**BUILDING
INNOVATIONS
AUSTRALIA**

BCA & ACCESS 2022 INDICATIVE COMPLIANCE REPORT FOR DA LODGEMENT

**320 King Georges Road,
Beverly Hills NSW 2209**

Prepared for:	L.A. Donuts
Project No.:	PRO-08462-J3N7
Date:	13/08/2024
Status:	Report Issue v2.0

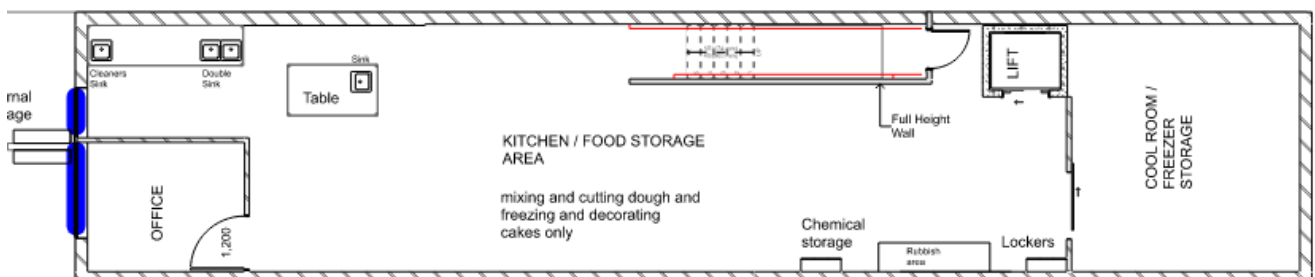
The following external wall openings are located within 3m from a fire source feature:

Ground Floor

- The north-eastern facing external wall opening of the garage;
- The north-eastern facing external wall opening of the tenancy corridor; and
- 3x south-western facing external wall opening of the store front.

First Floor

- The south-western facing external wall opening of the office; and
- The south-western facing external wall opening of kitchen.

Compliance can be achieved via compliance with Clause C4D5 and Specification 12 of the BCA or alternatively a fire engineering performance solution can be undertaken prior to the issue of the Construction Certificate.

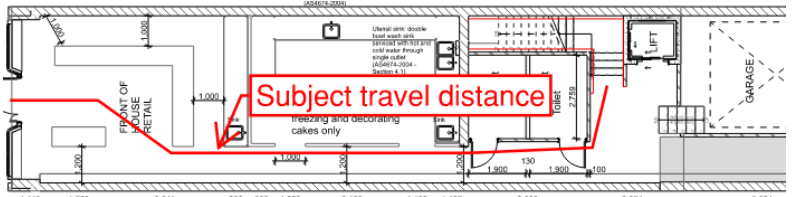
D2D5	Exit travel distances	PS	In a Class 5, 6, 7, 8 or 9 building, no point on a floor must be more than 20m from an exit, or a point from which travel in different directions to 2 exits is available; in which case the maximum distance to one of those exits must not exceed 40m. In a Class 5 or 6 building, the distance to a single exit serving a storey at the level of access to a road or open space may be increased to 30m. Compliance can be achieved via a fire engineering performance solution undertaken prior to the issue of the Construction Certificate.

The following distances on the ground floor level retains a distance of greater than 20m to a single exit:

Part D2 – Provision for Escape			
Clause	Description	Status	Comments
			 Compliance can be achieved via slight redesign or alternatively via undertaking a fire engineering performance solution prior to the issue of the Construction Certificate.
D2D9	Width of doorways in exits or paths of travel to exits	CRA	The unobstructed width of a doorway in a required exit or path of travel to exit must not be less than 750mm. Width of doorways in paths of travel in the building appear to comply with the requirements of this clause. Design verification to be provided by the designer prior to the issue of the Construction Certificate.
D2D10	Exit width not to diminish in direction of travel	CRA	The unobstructed width of a required exit must not diminish in the direction of travel to a road or open space. Design verification to be provided by the designer prior to the issue of the Construction Certificate.
D2D11	Determination and measurement of exits and paths of travel to exits	CRA	The unobstructed width of a stairway or ramp in a required exit or path of travel to an exit must be measured clear of all obstructions such as handrails, projecting parts of balustrades or other barriers and the like. The unobstructed height of a stairway or ramp in a required exit or path of travel to an exit must extend without interruption, except for ceiling cornices, to a height not less than 2m vertically above a line along the nosing of the treads or the floor surface of the ramp or landing. Design verification to be provided by the designer prior to the issue of the Construction Certificate.
